## **Urgent Field Safety Notice**

### **StealthStation™ S8 App version 2.0 and 2.0.1 (Model # 9735762)**

StealthStation™ S8 and StealthStation FlexENT™ Software Plan Data  
Shift with New Reference Exam

**Medtronic Reference: FA1361**

**Figure 3.** Pre-Merge/Diffusion Merge with Reference

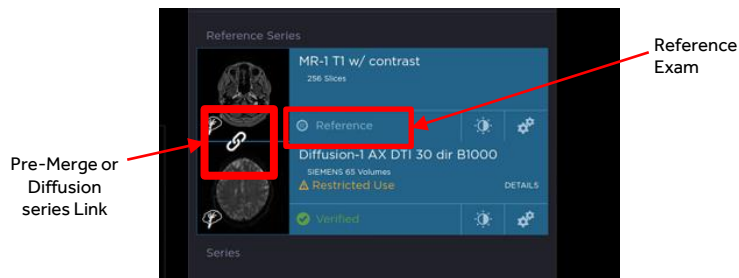
1. The navigation reference exam is merged with either a diffusion series (for tractography processing) or a pre-merge type series (an exam that does not contain anatomical information that must already be aligned or pre-merged to the anatomy in the reference exam - examples are a functional MRI activation map overlay or a PET exam).

**Note:** The icon link in **Figure 3**, below indicates the use of pre-merge or diffusion merge. Merged images without this icon link is not impacted by this anomaly.

Medtronic recommends that users do not change the reference exam after establishing a surgical plan if the original reference exam included pre-merge or diffusion merge exam. The incorrect surgical plan data **cannot** be recovered by reverting to the original reference exam. To resolve this issue, the user must manually update the existing plans to the original locations or make new plans.

**Figure 4.** Pre-Merge/Diffusion Merge with changed Reference

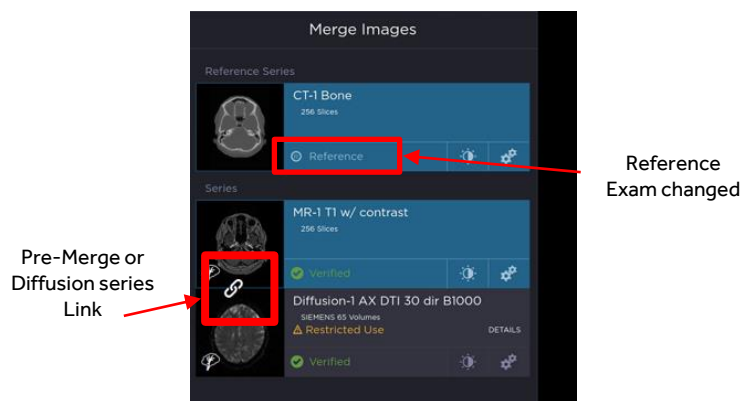
2. Surgical planning data (surgical plans, annotations, or AC-PC data) is established based on the reference exam with the Pre-Merge or Diffusion Merge exams.
3. The reference exam is changed to a different exam as seen in **Figure 4**, below.

In accordance with the IFU: Verify that a plan's target point, entry point, and trajectory are clinically valid before using it for a procedure. Traverse the surgical plan to check the entry, target, and trajectory after any edit.
